SEMINOLE COUNTY GOVERNMENT
 1101 EAST FIRST STREET, 2ND FLOOR, WEST WING
 SANFORD, FLORIDA 32771

PROJECT NAME:	SAND LAKE RD - PRE-APPLICATION	PROJ #: 24-80000038
APPLICATION FOR:	DR - PRE-APPLICATION DRC	
APPLICATION DATE:	3/08/24	
RELATED NAMES:	EP BRENDA PEARCE	
PROJECT MANAGER:	KATHY HAMMEL (407) 665-7389	
PARCEL ID NO.:	08-21-29-524-0100-0000	
PROJECT DESCRIPTION	PROPOSED SPECIAL EXCEPTION FOR A NEW WATER METER SYSTEM INSTALLATION ON 0.02 ACRES IN THE PD ZONING DISTRICT LOCATED ON THE SOUTH SIDE OF SAND LAKE RD, EAST OF HUNT CLUB BLVD	
NO OF ACRES	0.02	
BCC DISTRICT	3-LEE CONSTANTINE	
CURRENT ZONING	PD	
LOCATION	ON THE SOUTH SIDE OF SAND LAKE RD, EAST OF HUNT CLUB BLVD	
FUTURE LAND USE-	PD	
APPLICANT:	CONSULTANT:	
BRENDA PEARCE BLACK & VEATCH/SUNSHINE 200 WEATHERSFIELD AVE ALTAMONTE SPRINGS FL 32714 (678) 656-5179 PEARCEB@BV.COM	N/A

PROJECT AREA ZONING AND AERIAL MAPS

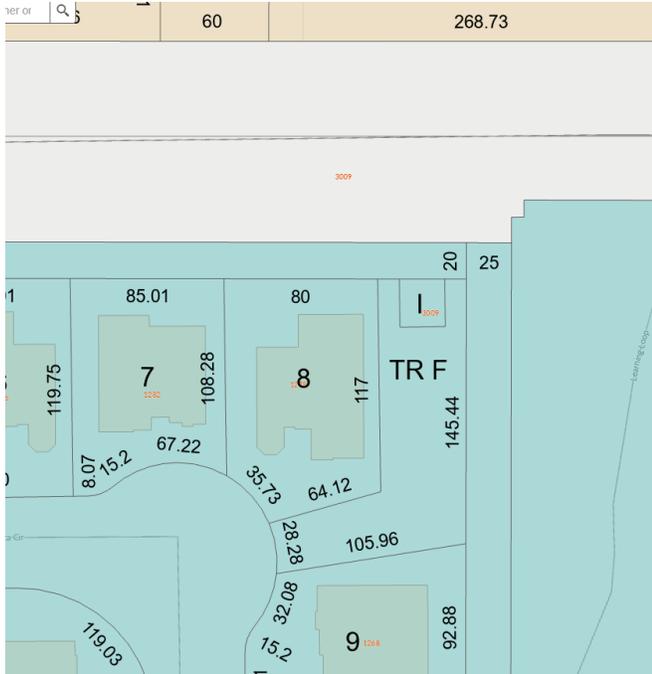
The parcel is located within unincorporated Seminole County and within the Forest Lake Academy Planned Development (PD).
